Access Compliance Report

Public Rights-of-Way

(Curb Ramps)

Intersection ID: 47361	Main Street: PARK_RD	Cross Street: BROOKSIDE_AV	Location: W
ADA ID: A5D5353A7566	Ramp Type: Perp	Initial Pass/Fail: Fail	Overall Compliance: No
			Severity Score: 13.75

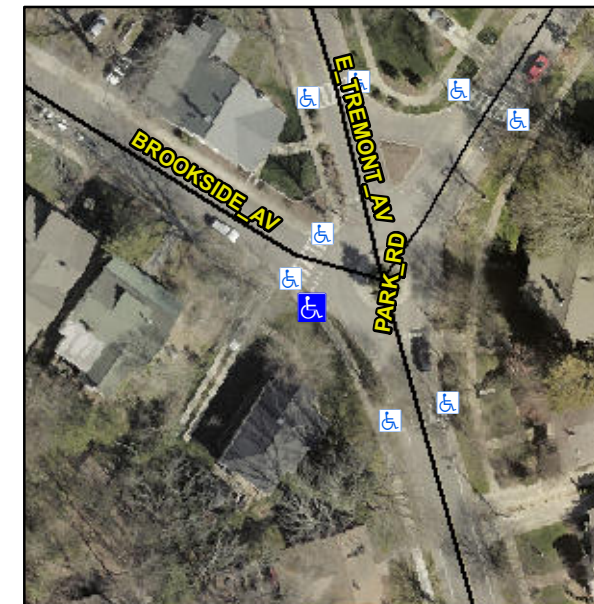
Not Found, R304.2.2, R304.5.3

Compliance	Description	Data	Compliance	Description	Data
N/A	Ramp Length (in)	45.0	No	Ramp Slope (%)	8.8
Yes	Ramp Width (in)	112.0	No	Ramp XSlope (%)	3.0
N/A	Flare Type LT	N/A	N/A	Flare Type RT	N/A
N/A	Flare Slope LT (%)	N/A	N/A	Flare Slope RT (%)	N/A
N/A	Flare Traversable LT?	N/A	N/A	Flare Traversable RT?	N/A
N/A	Landing Length (in)	N/A	N/A	DWS Provided?	N/A
N/A	Landing Width (in)	N/A	N/A	DWS Contrast?	N/A
N/A	Landing Slope (%)	N/A	N/A	DWS Length (in)	N/A
N/A	Landing X Slope (%)	N/A	N/A	DWS Full Width?	N/A
N/A	Landing Curb? (Y/N)	N/A	N/A	DWS Offset (in)	N/A
N/A	Shared Landing?	N/A			
N/A	Gutter Ponding?	N/A	N/A	Gutter Slope (%)	N/A
N/A	Gutter Lip Ht (in)	N/A	N/A	Gutter X Slope (%)	N/A
N/A	Painted X Walk1?	No	N/A	Painted X Walk2?	N/A
	X Walk 1 Direction	To N		X Walk 2 Direction	N/A
N/A	X Walk 1 Width (in)	N/A	N/A	X Walk 2 Width (in)	N/A
	X Walk 1 Slope (%)	2.8		X Walk 2 Slope (%)	N/A
	X Walk 1 X Slope (%)	5.0		X Walk 2 X Slope (%)	N/A

Remove & Replace Entire Ramp.
